Application for MAJOR SUBDIVISION Approval

**DATE:** June 13<sup>th</sup>, 2019  
**TO:** Village of North Hudson Plan Commission Members  
**FROM:** Kevin Oium, Village Engineer  
**REGARDING:** Preliminary Plat Review for The Ridges 2<sup>nd</sup> Addition

The Ridges 2<sup>nd</sup> Addition

# THE RIDGES 2ND ADDITION PRELIMINARY PLAT

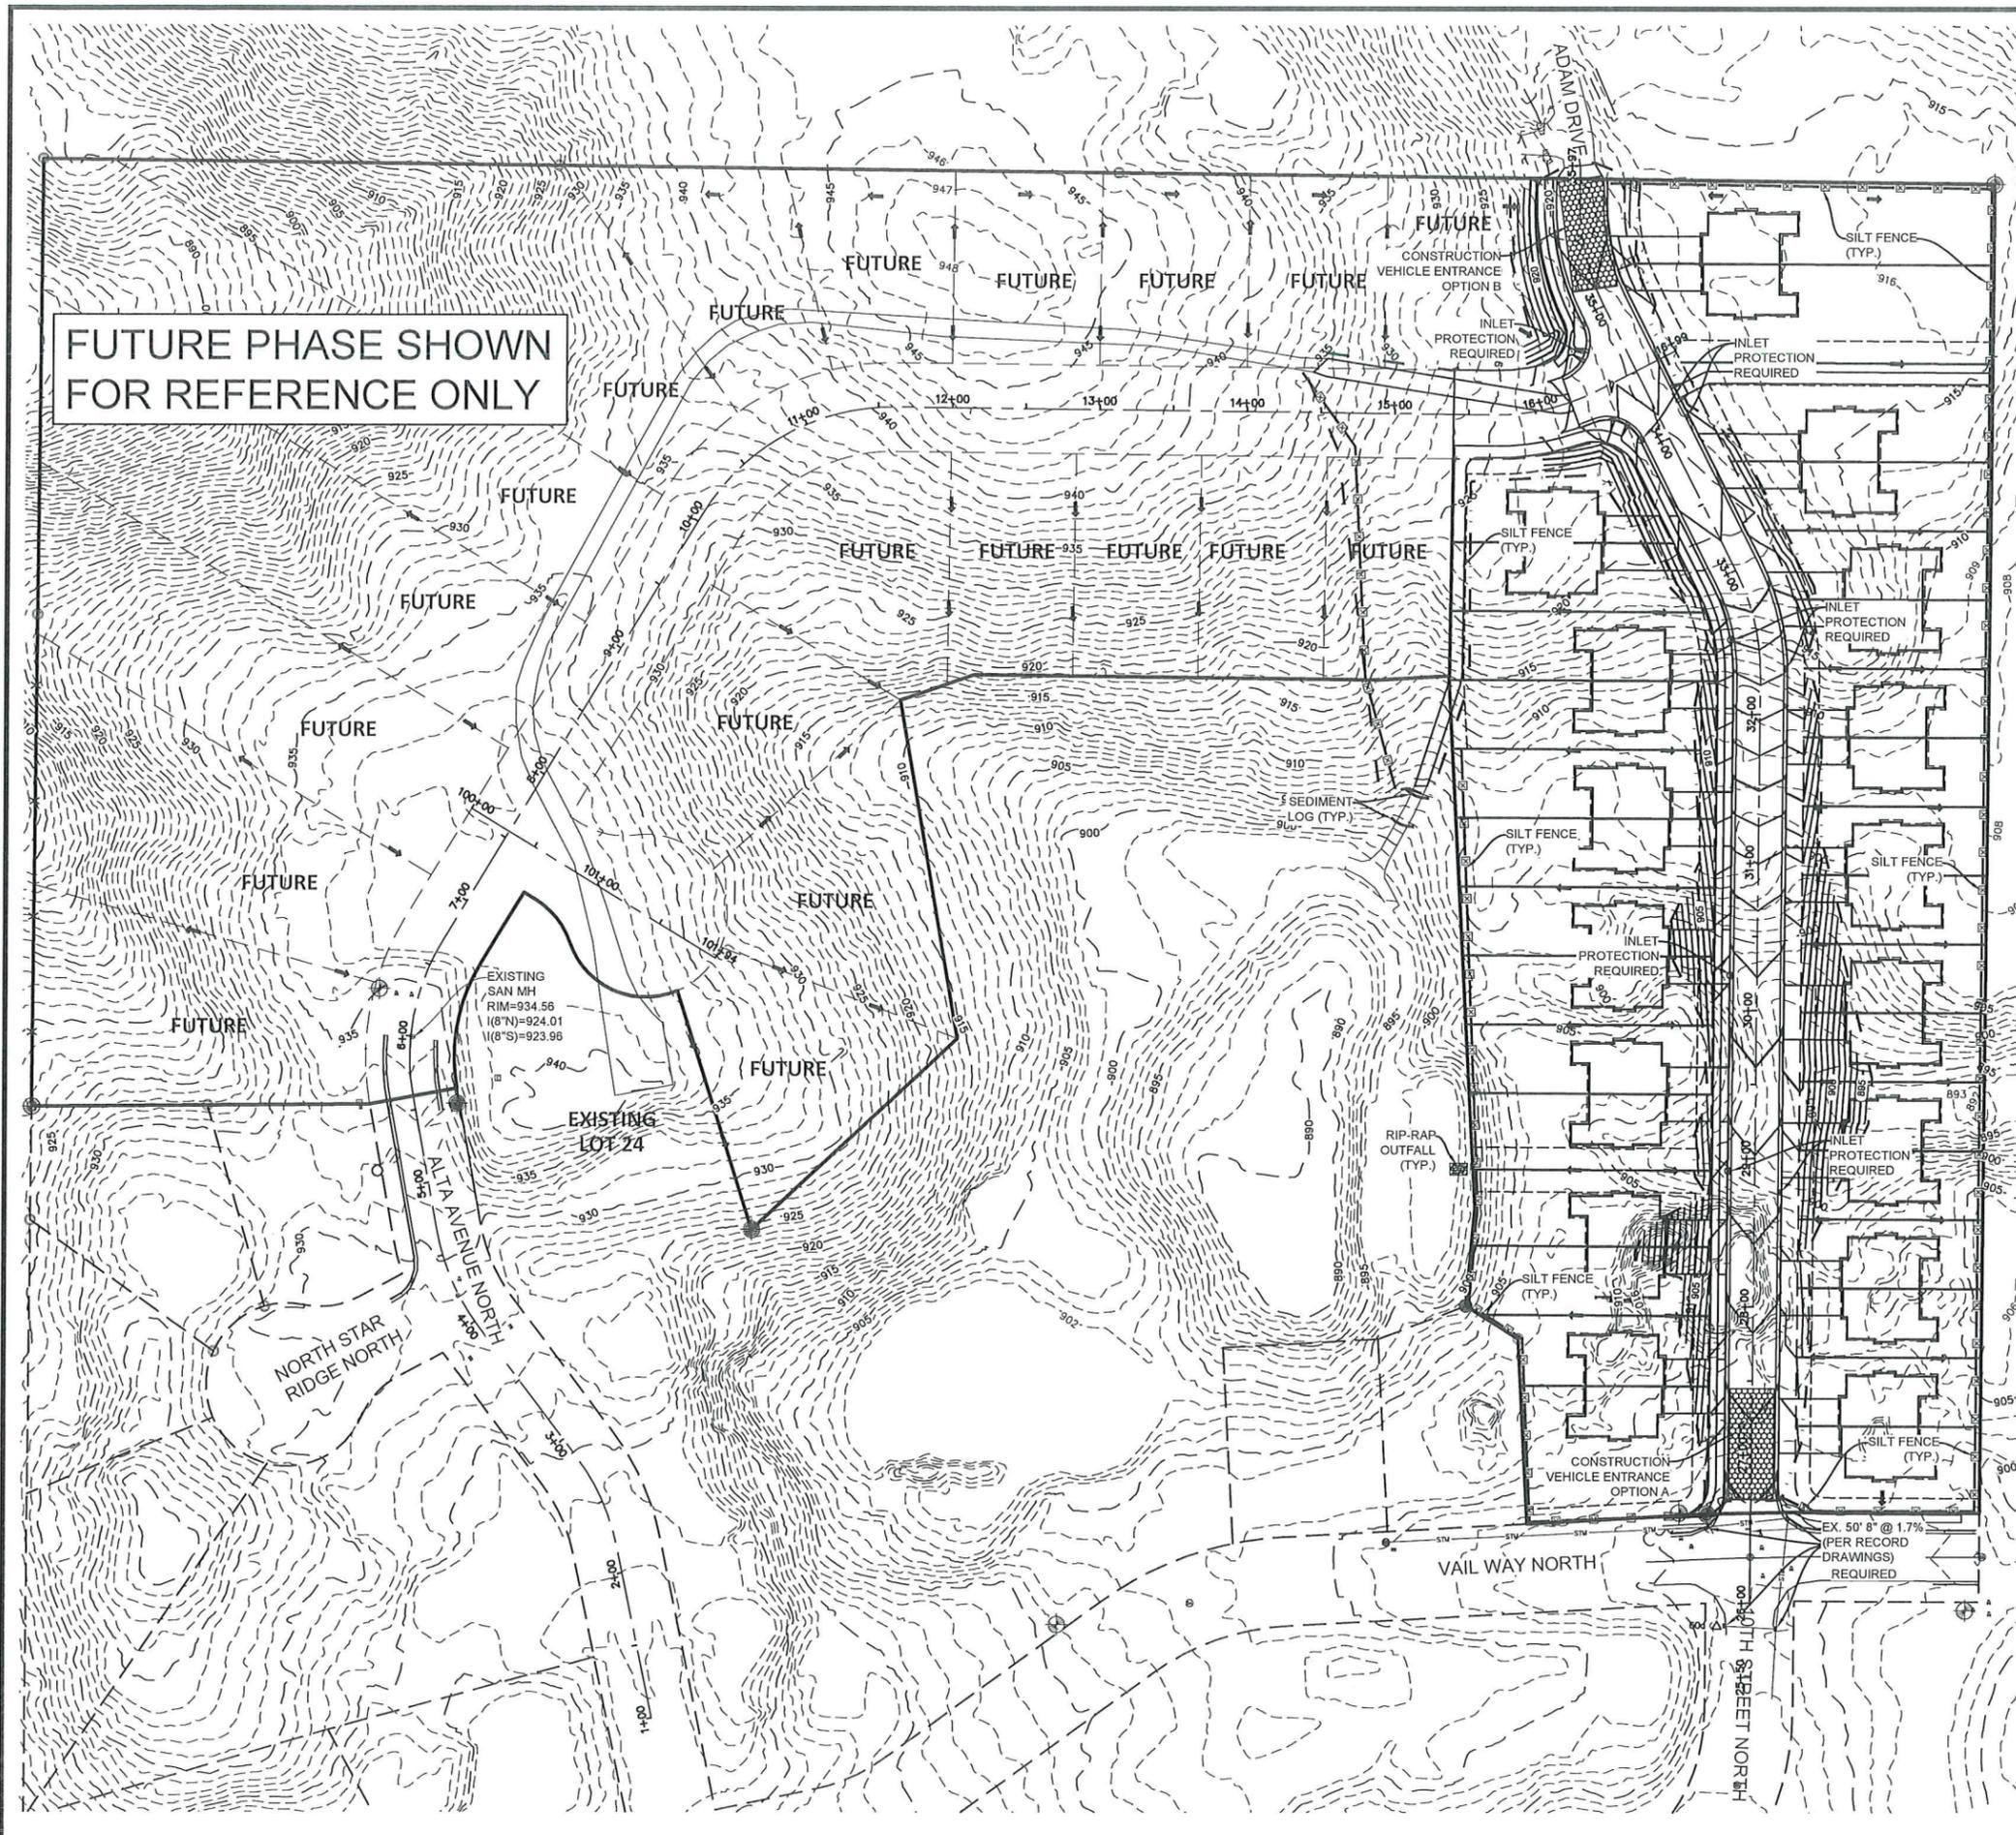
8. Provide a mass grading plan showing the grades for the streets, sidewalks, twin homes, driveways and walking paths.
9. Provide sizing calculations for the proposed storm sewer.
